CANTERBURY EARTHQUAKES ROYAL COMMISSION - REQUIREMENT FOR
INFORMATION - RECEIVED 19 SEPTEMBER 2011

Royal Commission of Inquiry into Building Failures Caused by the Canterbury Earthquakes: Requirement for Information

The Royal Commission's Terms of Reference require the Commission to inquire into the nature and effectiveness of any assessment carried out on the PGC Building at 233 Cambridge Terrace after the 4 September 2010 earthquake and 26 December aftershock.

Photographic Summary of Primary Damage Observed – 16 Sept 2010

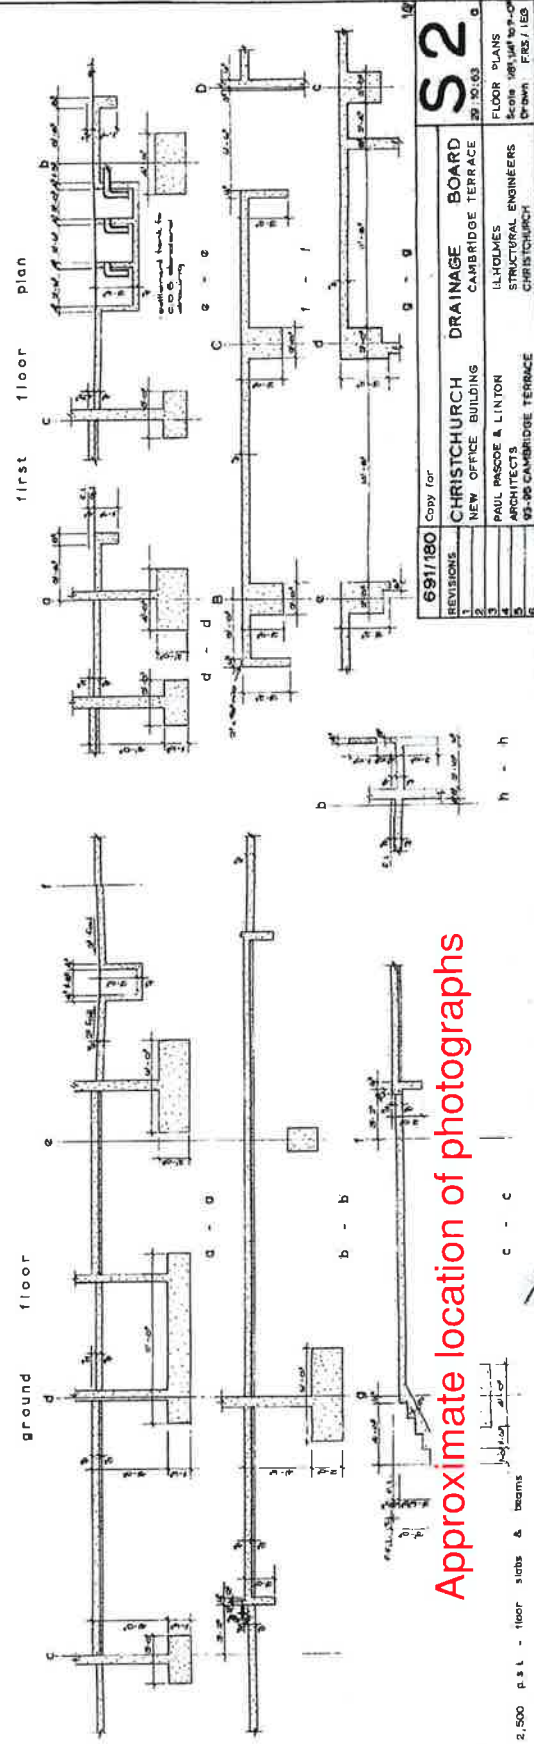
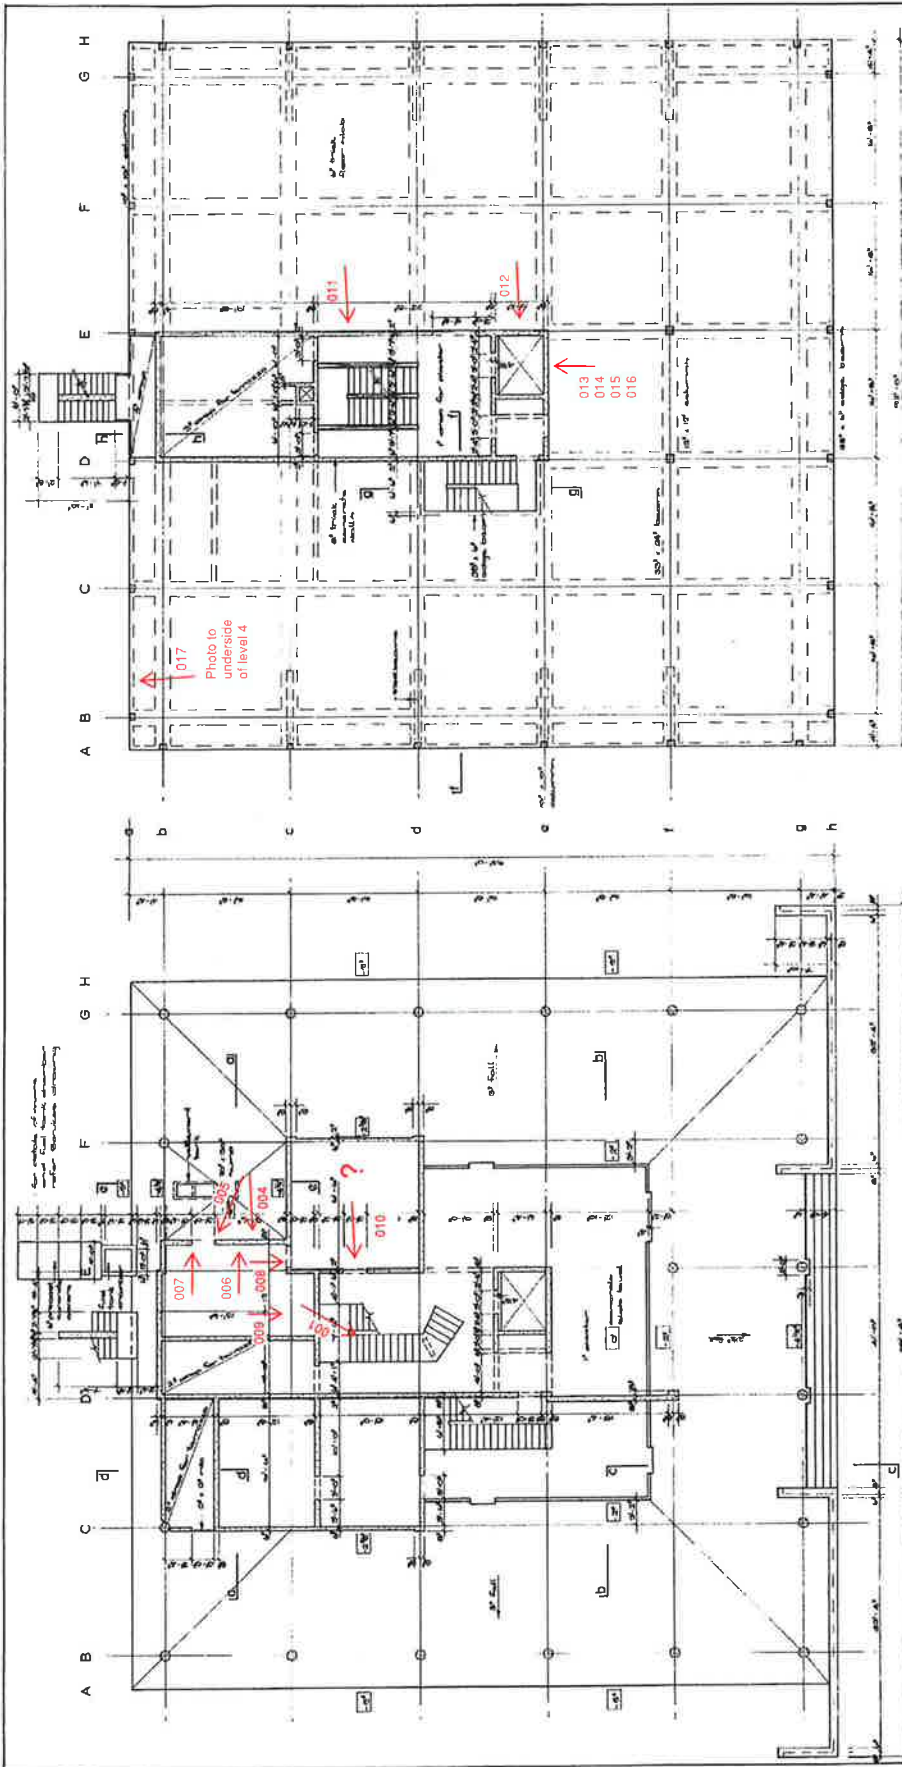
4. *In relation to the statement in the report, 'All cracks minor in shear walls', where were these cracks located and how large were they?*

As illustrated in the photographic record the cracking to the shear walls was predominantly on the Ground and First Floors and were generally 0.2-0.3mm. The largest of the cracks was located on the E-W shear wall at the south of the lift core (refer photographs 013-017 in the attached document) and were 0.2-0.6mm.

Damaged Item	Example
<p>Photo 001</p> <p>Minor cracking to underside stairs to L1 Typically $\leq 0.2\text{mm}$</p>	
<p>Photo 002</p> <p>Cracking to G floor shear wall Typically $\leq 0.2\text{mm}$</p>	
<p>Photo 003</p> <p>Cracking to G floor shear wall Typically $\leq 0.2\text{mm}$</p>
